CITY OF KETCHUM, IDAHO

2. ACTION ITEM: Recommend commission review, approve either Redesign #1 or Redesign #2 of the Lot 33, Block 4, Warm Springs Ranch Residences Design Review application, as conditioned, and direct staff to return with the Findings of Fac

STAFF REPORT KETCHUM PLANNING AND ZONING COMMISSION REGULAR MEETING OF APRIL 9, 2024

WARM SPRINGS RESIDENCE #33 R1

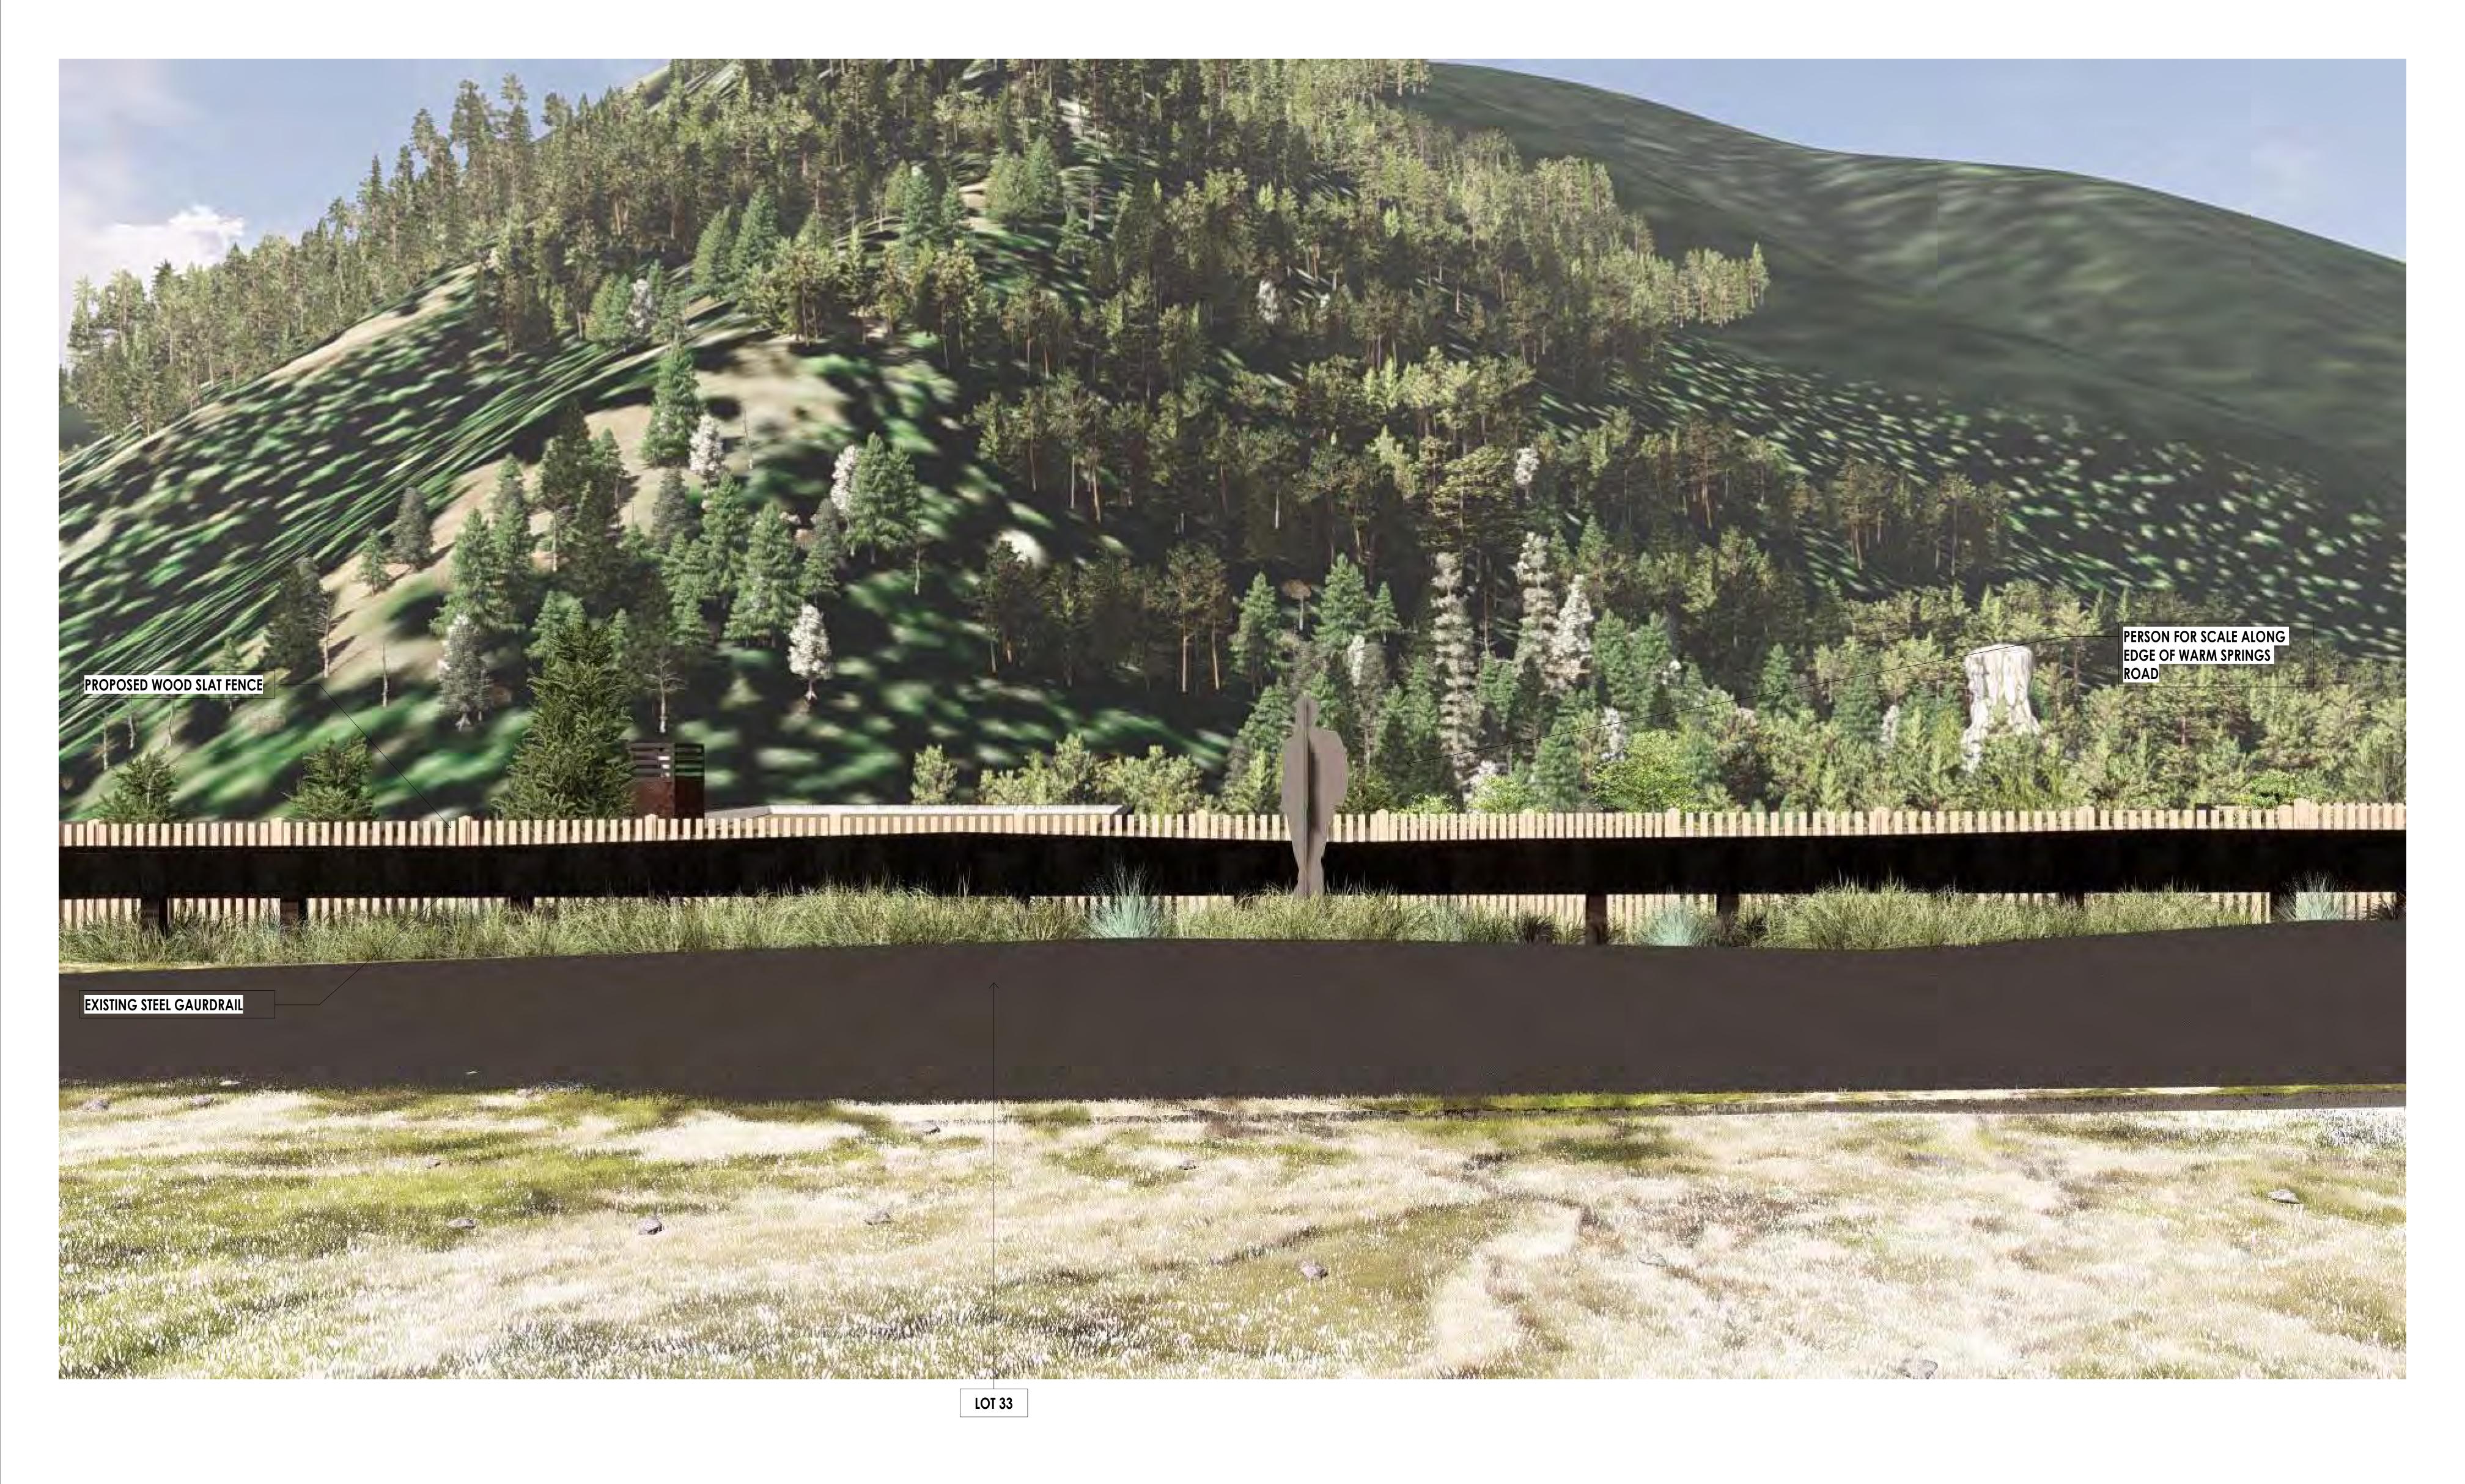
- Retains flat roofs
- Massing reduced from 3 stories to 2
- Building height reduced by 3'-8" (new maximum building height of 29'-0 ½")
- Chimney height reduced by 4'
- Elevator (and elevator shaft) removed
- Roof parapet is a maximum of 2' above Warm Springs Road curb
- Exterior materials revised to an over grouted natural stone and natural wood in a horizontal lap

WARM SPRINGS RESIDENCE #33 R2

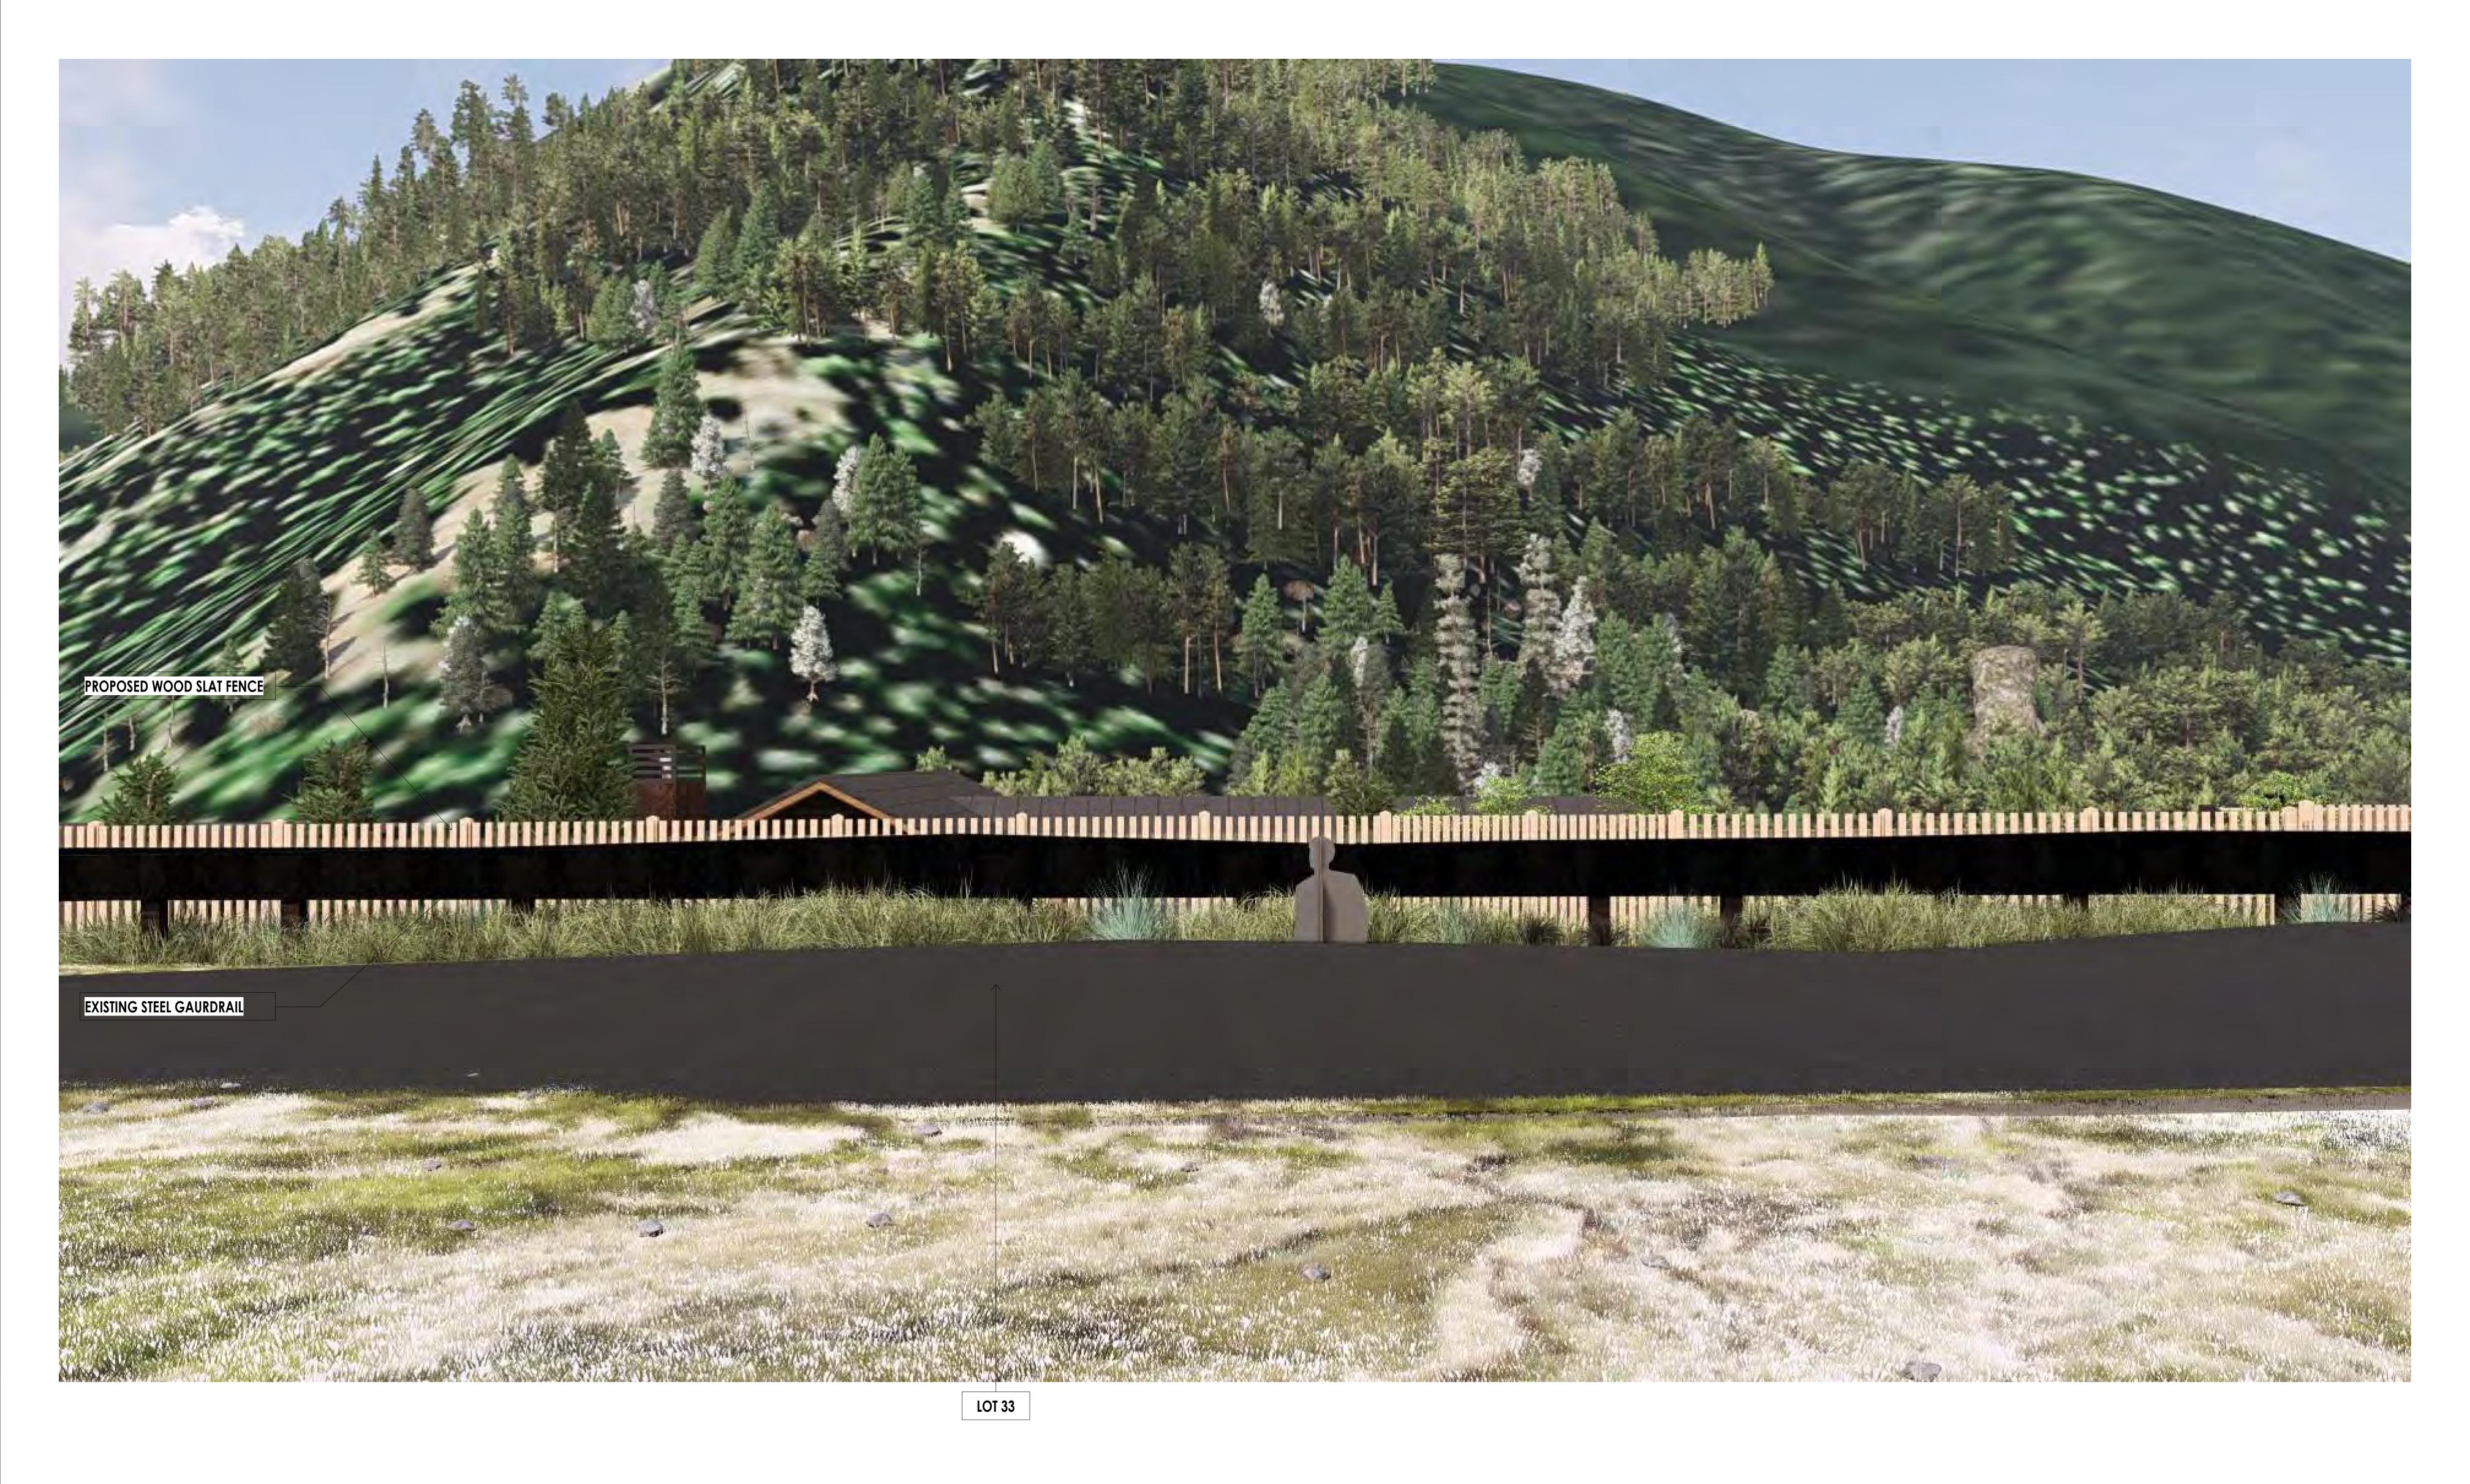
- Features traditional 6:12 pitched roofs with minor flat roof accent areas
- Massing reduced from 3 stories to 2
- Building height reduced by ~1'-4" (new maximum building height of 31'-10 169/256")
- Chimney height reduced by 4'
- Elevator (and elevator shaft) removed
- Roof parapet is a maximum of 5' above Warm Springs Road curb
- Exterior materials revised to an over grouted natural stone and natural wood in a horizontal lap
